**Amendments to the Drawings:**

The attached sheets of drawings show amended Figures 1, 2, 3, 9, 10 and 14.

Figure 1

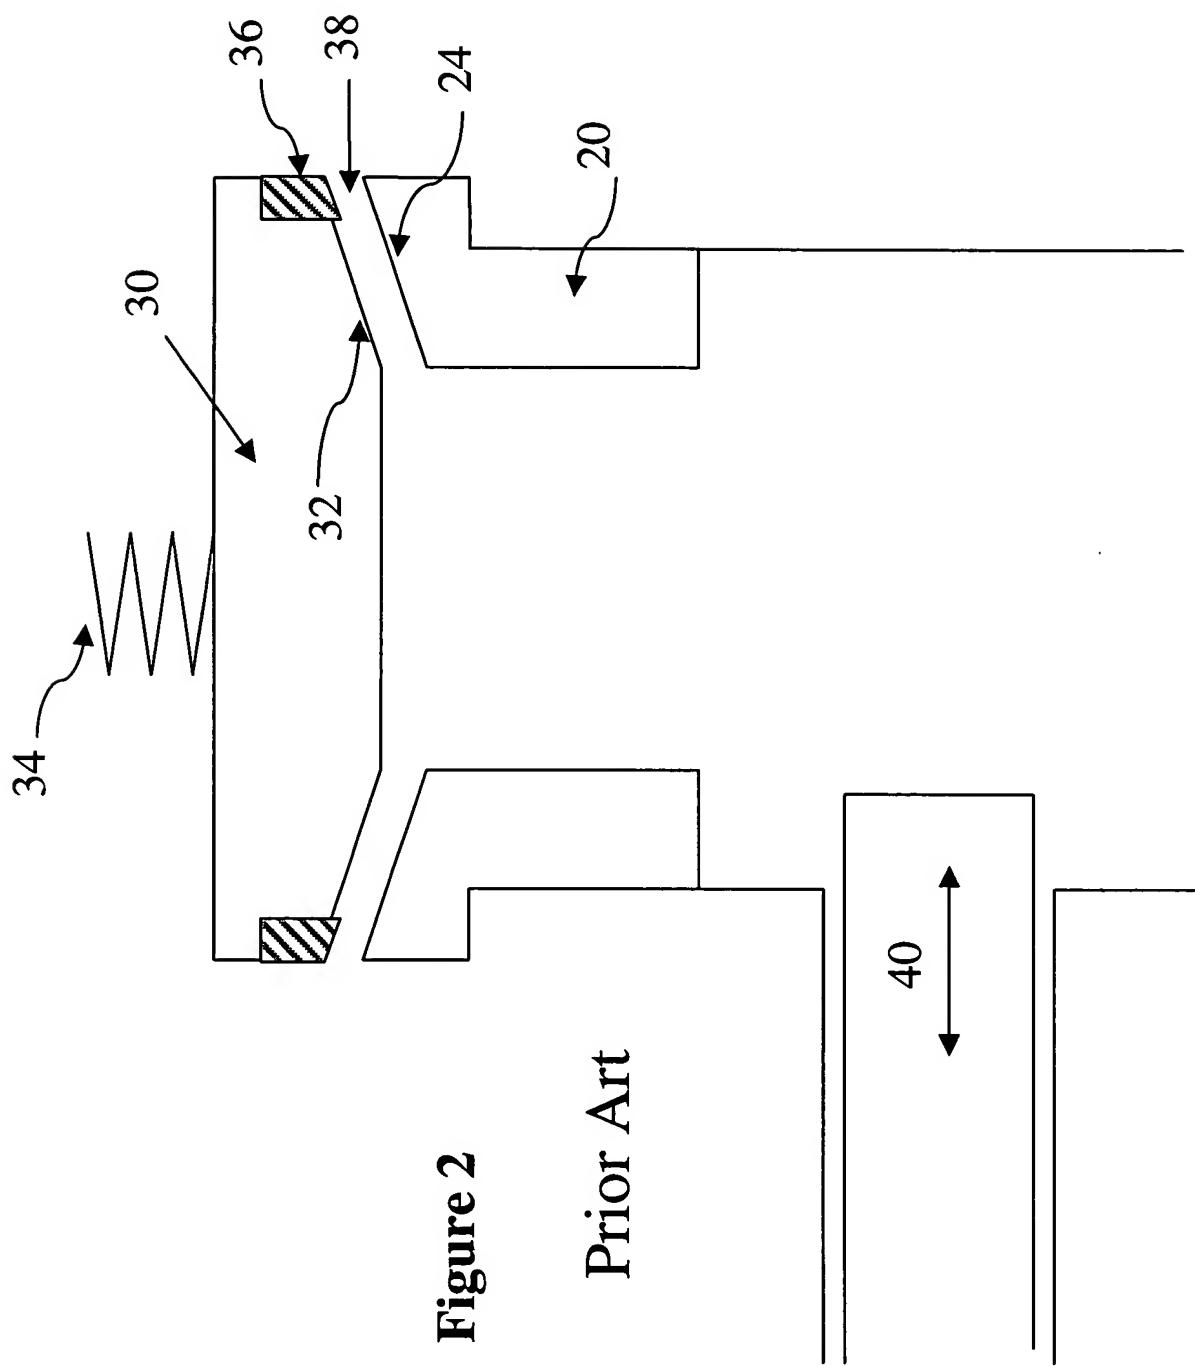
In response to Examiner Rivell's requirement, Applicants submitted the revised versions of Figures 1, 2, 3, and 14 with the legend "Prior Art" added to each Figure.

Figure 10

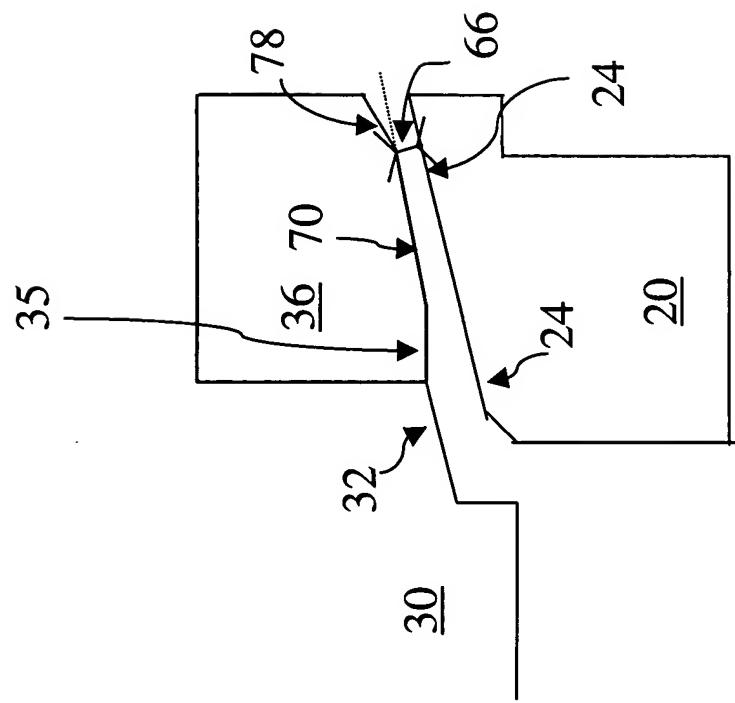
In Figure 9, the line portion of the indicator (a pair of arrowheads connected by a line) used to locate the inner valve exit gap, 66, has been shortened slightly so that the gap is clearly shown to be between the juncture of the surfaces 35 and 72 and the surface 24. In the original drawing the line had inadvertently been shown extended into the insert 36. In Figures 9 and 10, an arrow and the reference character 35 have been added to indicate the location of the first insert contact surface. On Figure 10, an indicator, an arrow and the reference character 66 have been added to show the location of the inner valve exit gap, and to show that the inner valve exit gap is not at the same location as it is in the embodiment shown in Figure 9.
